Report Type: CC Access Report
Reference Number: 19064B
Client: Complete Urban
Site Address: Werrington Downs Neighbourhood Centre
2 Brookfield Ave, Werrington downs, NSW

ACCESS REPORT

This Access Compliance Report is to accompany a Construction Certificate Application for the development proposed at Werrington Downs Neighbourhood Centre at 2 Brookfield Ave, Werrington downs, NSW.

This development proposes Additions and Alterations to an Existing building for a Community Centre facility. The development is within Penrith City Council LGA.

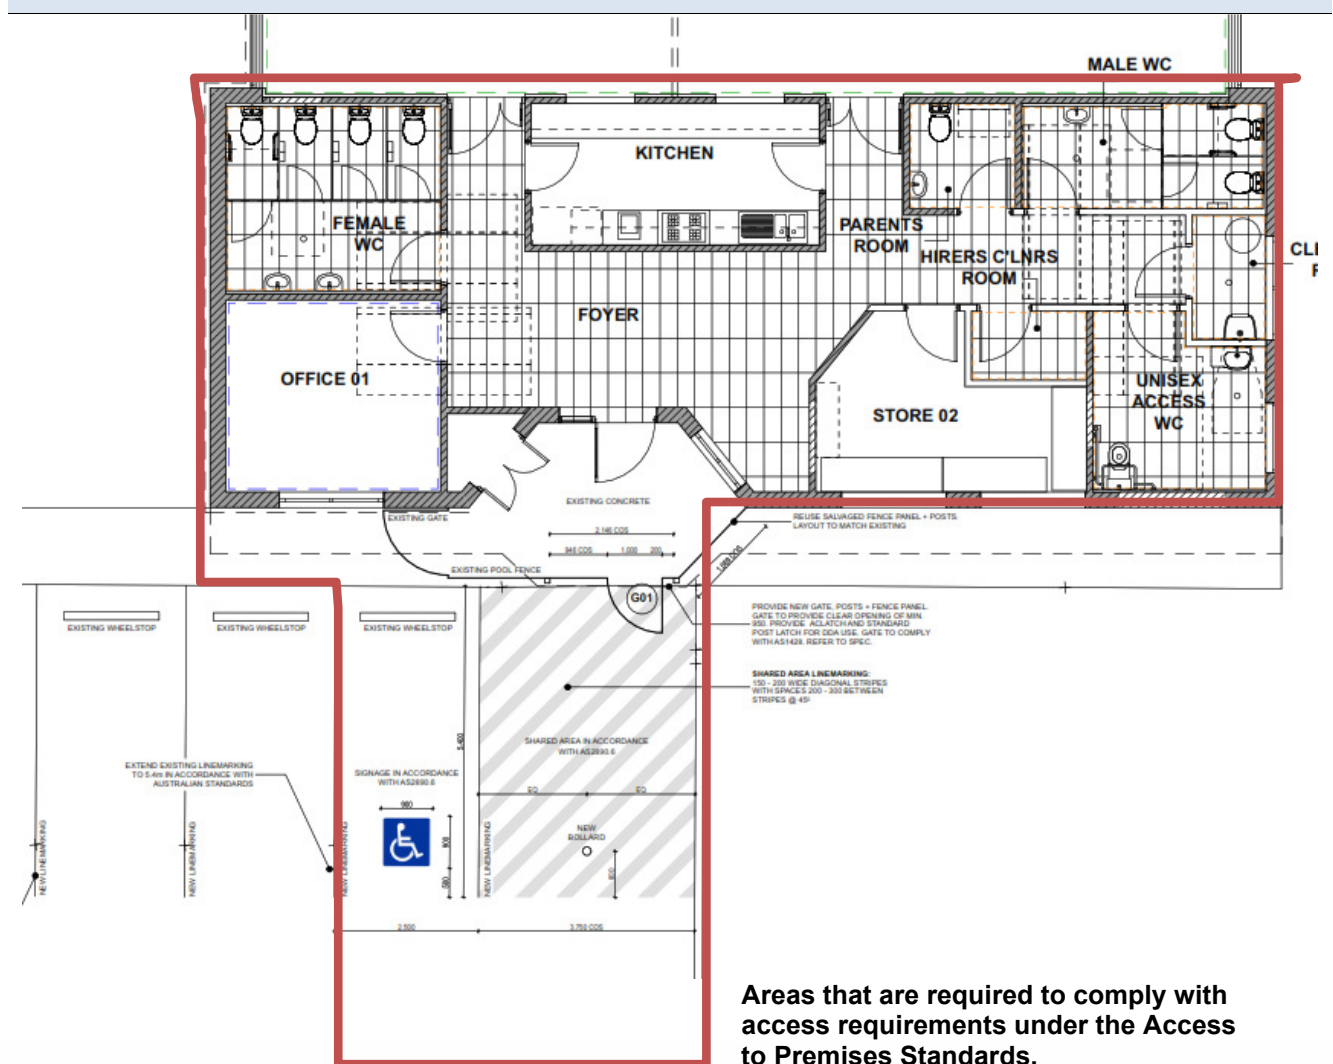
Compliance Comments	<p>Capable of compliance.</p> <p>As stated in the above requirements, APS only applies to,</p> <ul style="list-style-type: none"> - New works, - Modified works and - Works within the 'affected part' <p>In this development, the new works, modified works and works within the 'affected part' have been shown in the plan below with a red boundary.</p>
